Appendix A

Comment Submissions received from Tribes and Agencies

In future correspondence please refer to:
Project Tracking Code: 2018-02-01251
Property: Tacoma Dome Link Extension
Re: Draft Programmatic Agreement Review Comments

RE: Draft EIS Comment - TDLE

ALL SFW TO FIFE ALTERNATIVES
TRACK PLAN AND PROFILE
STA 1926+00 TO STA 1951+00

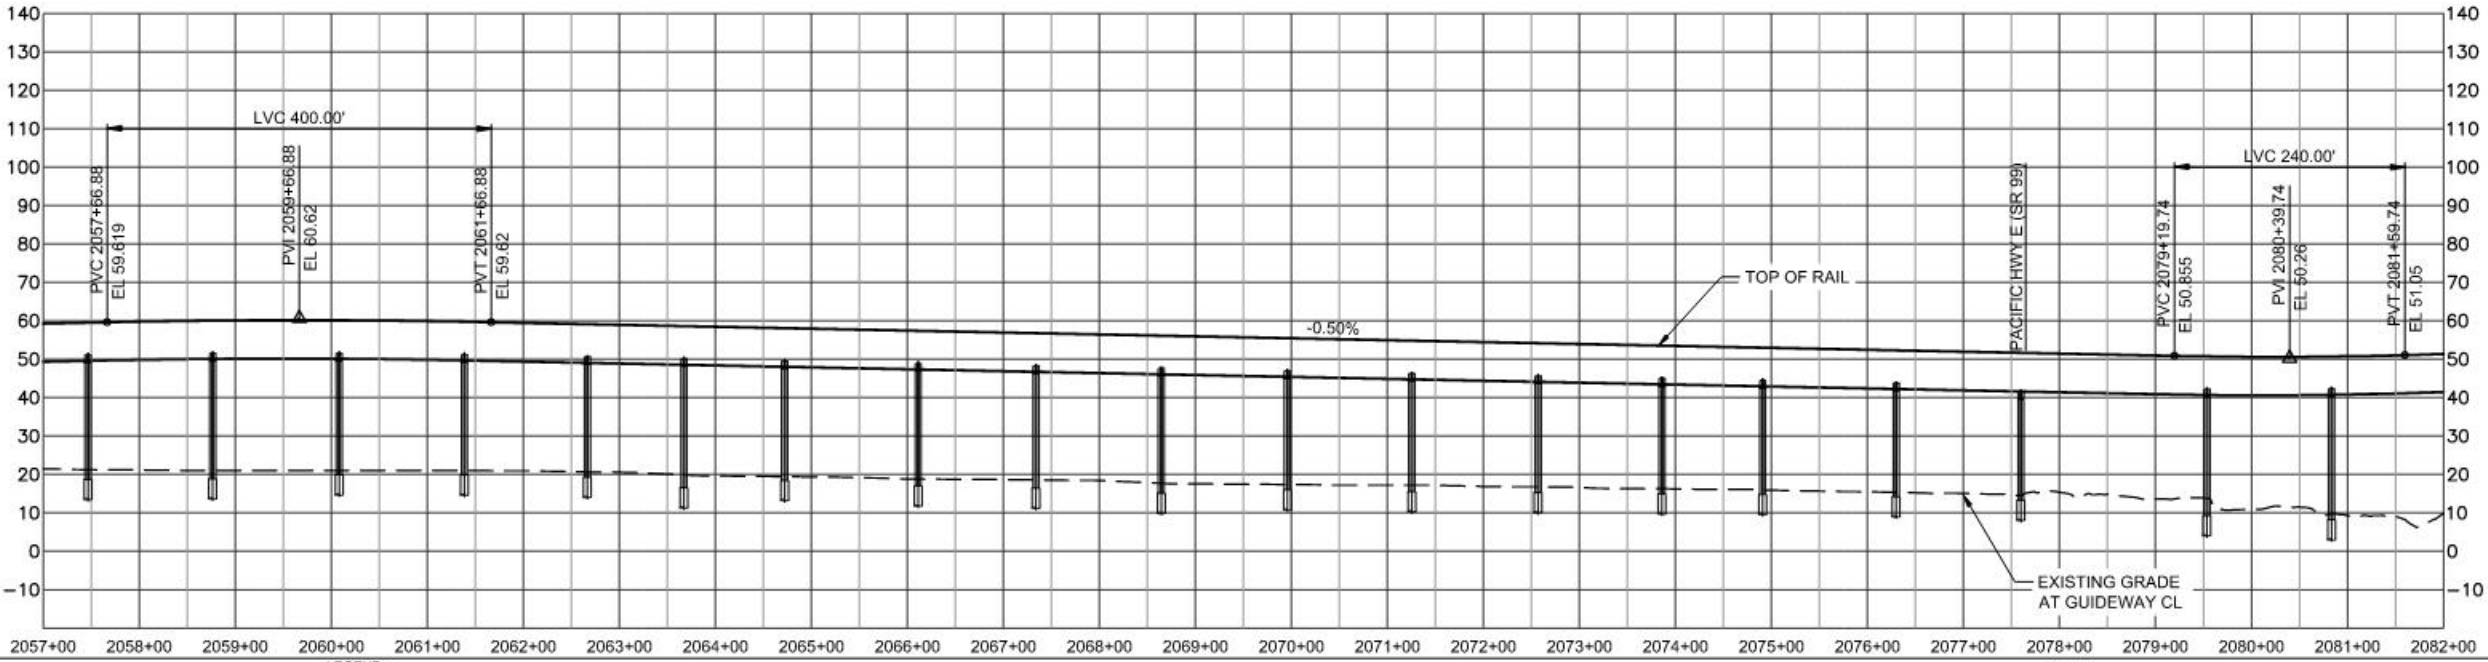
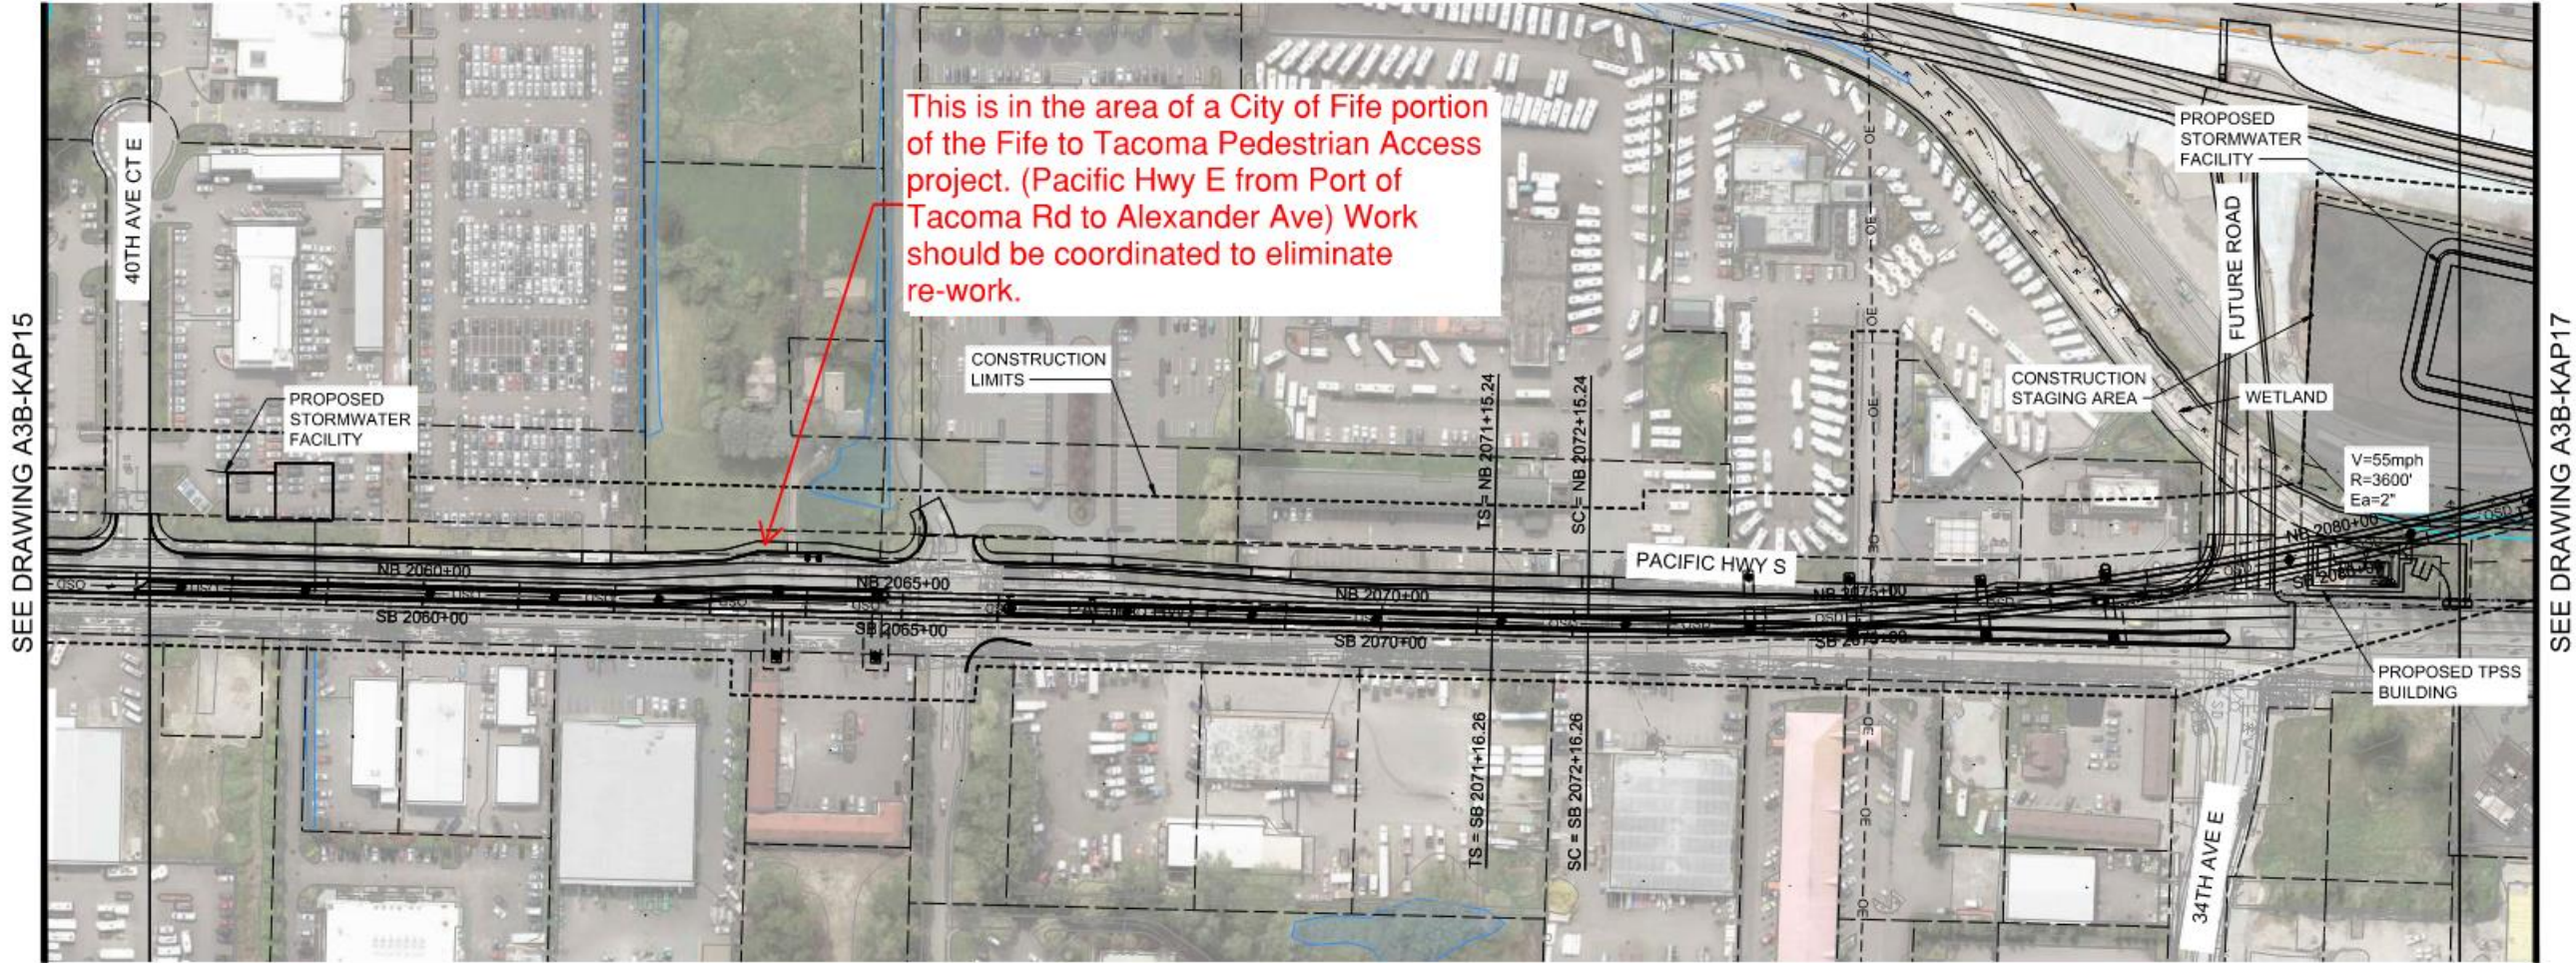
Existing grade has changed as RRP in this area was graded in summer 2024. Survey data and basis of design stream and wetland layer will require updates to reflect new existing conditions.
